MEMORIAL STADIUM – NORTH CONCOURSE VIDEO BOARD REPLACEMENT

ADDENDUM #01

TO CONTRACT DOCUMENTS FOR: Project #CP241291
ADVERTISEMENT DATE: March 27, 2024
PREPARED FOR: The Curators of the University of Missouri
CONSULTANT: POPULOUS
4800 Main Street, Suite 300
Kansas City, MO 64112
(816) 221-1500

ELEVATION VIEW
FRONT

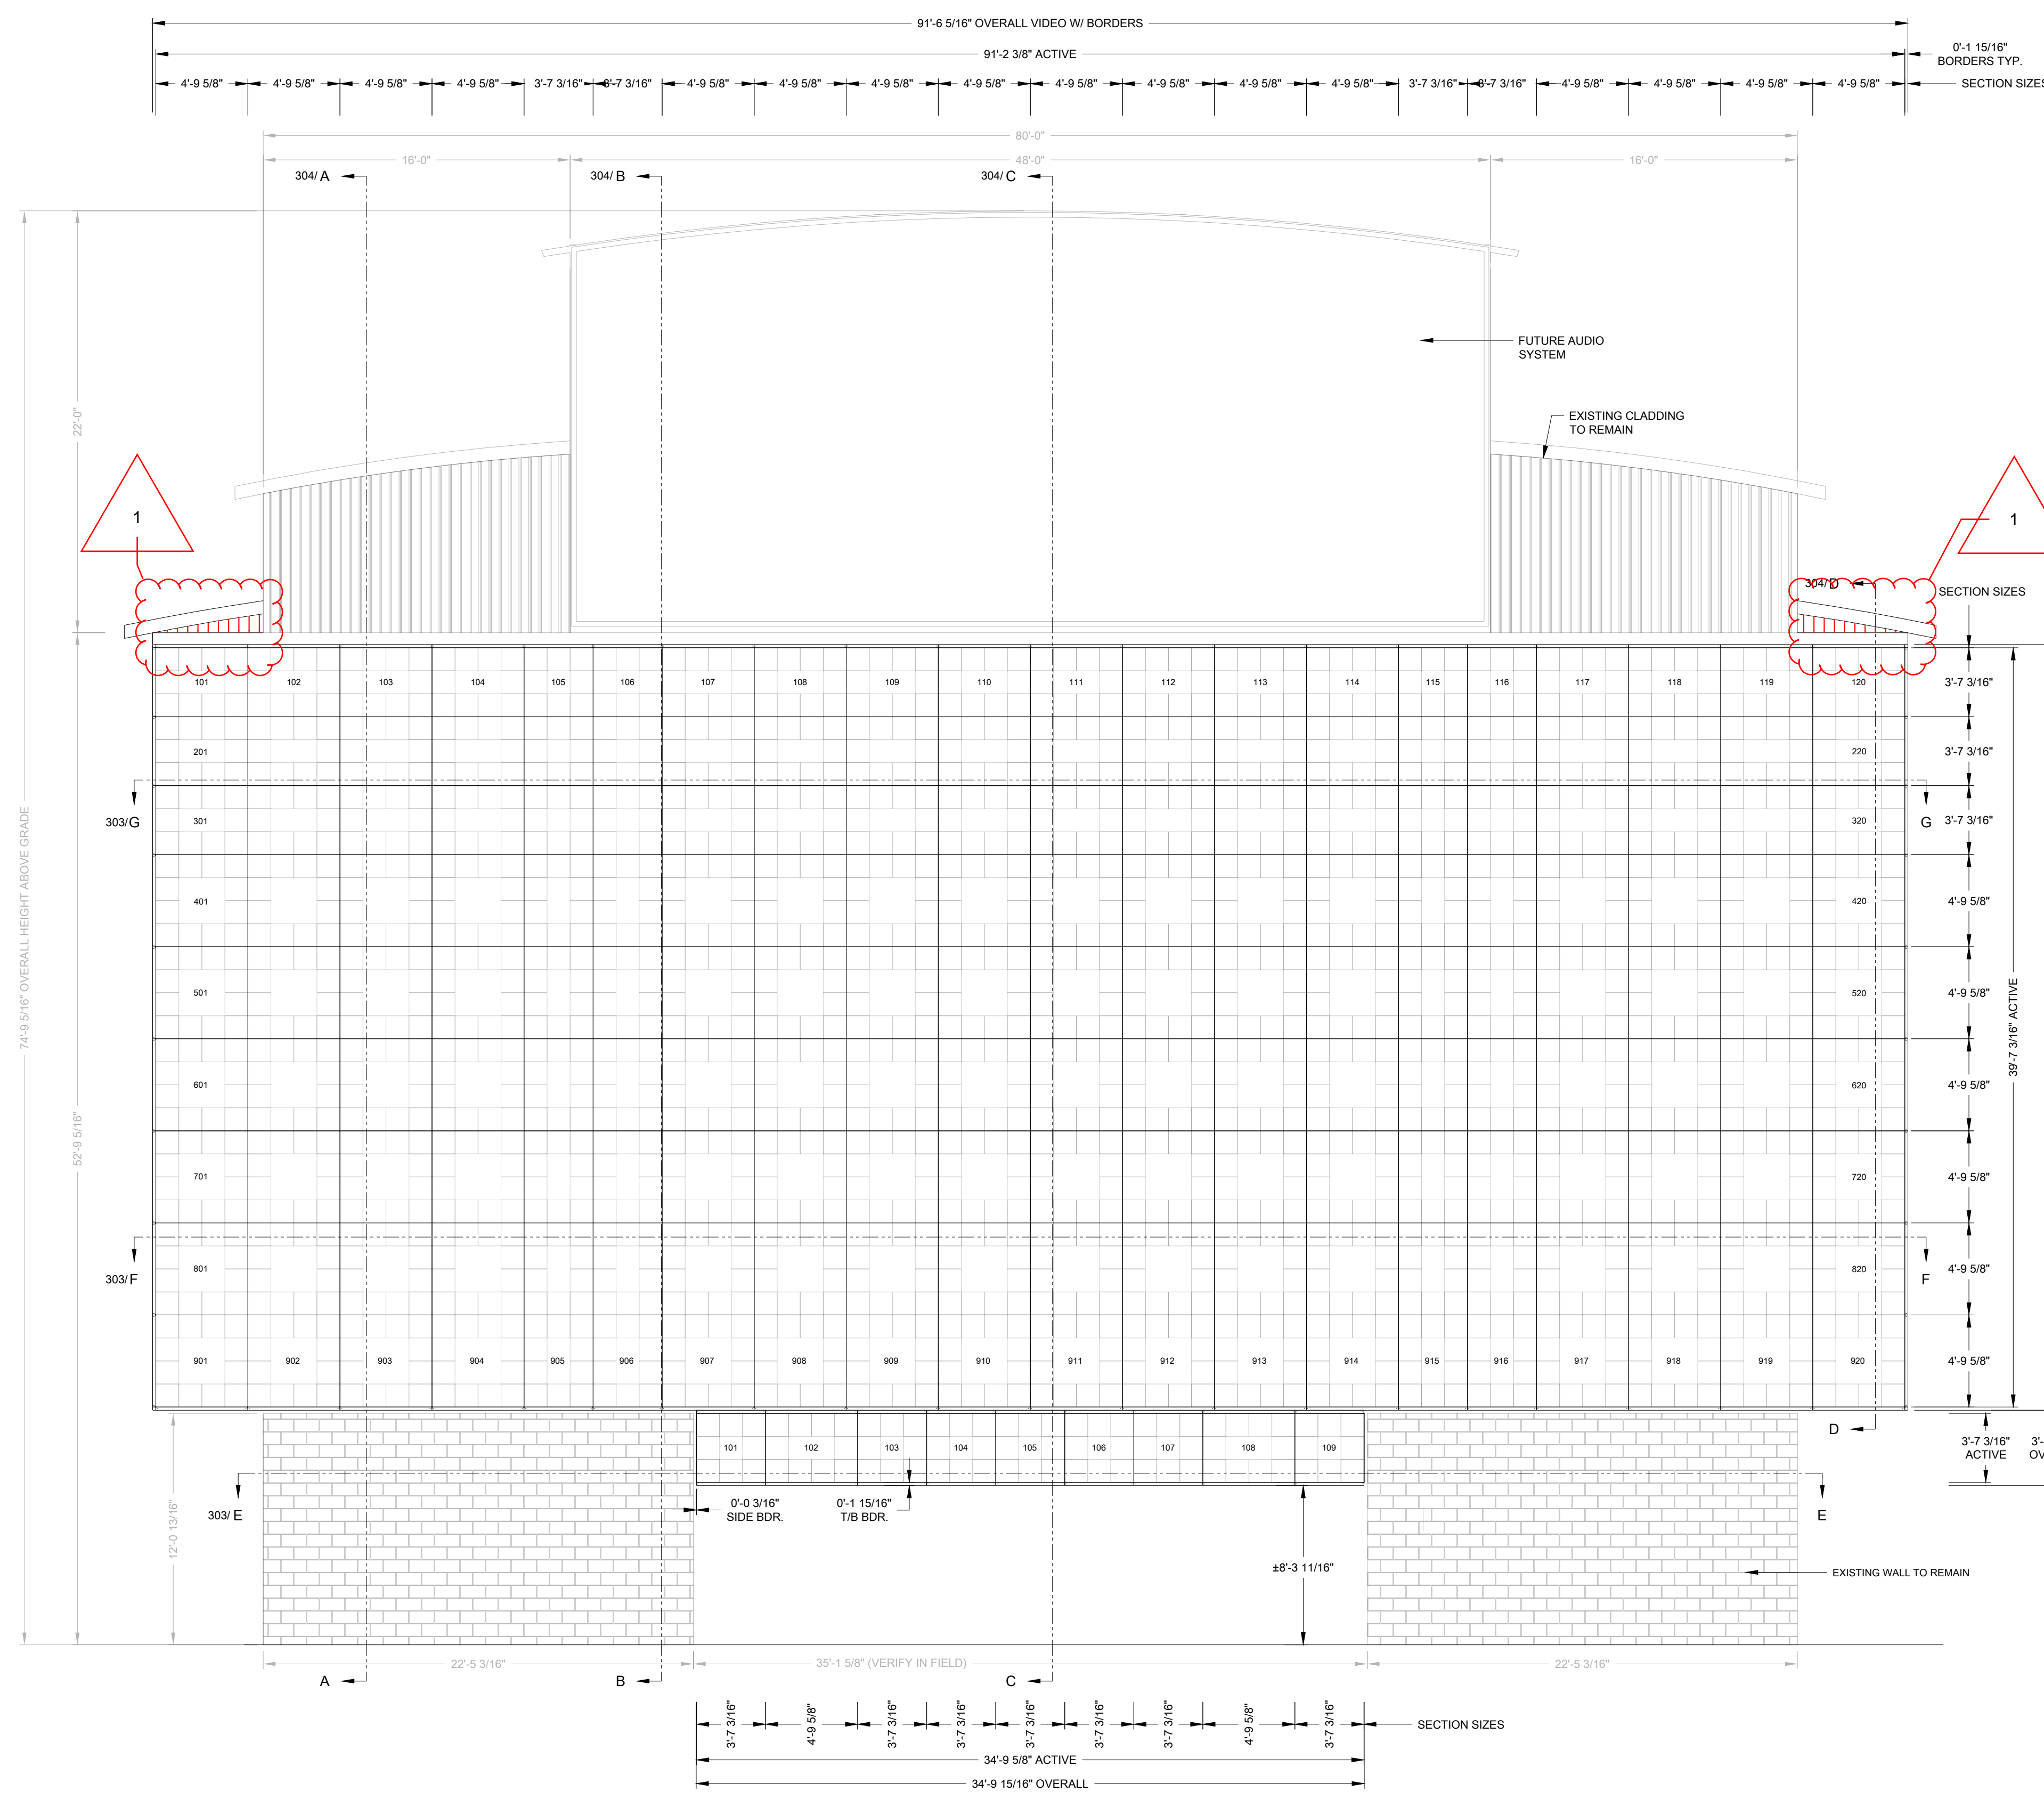
- 1) G001 – COVER SHEET
 - a. Updated Sheet Index to show revised sheets.
- 2) V301 – FRONT ELEVATION VIEW
 - a. Updated to show metal wall panel between top of board and new roof.
- 3) V302 – REAR ELEVATION VIEW
 - a. Updated to show metal panel extending up to new roof.
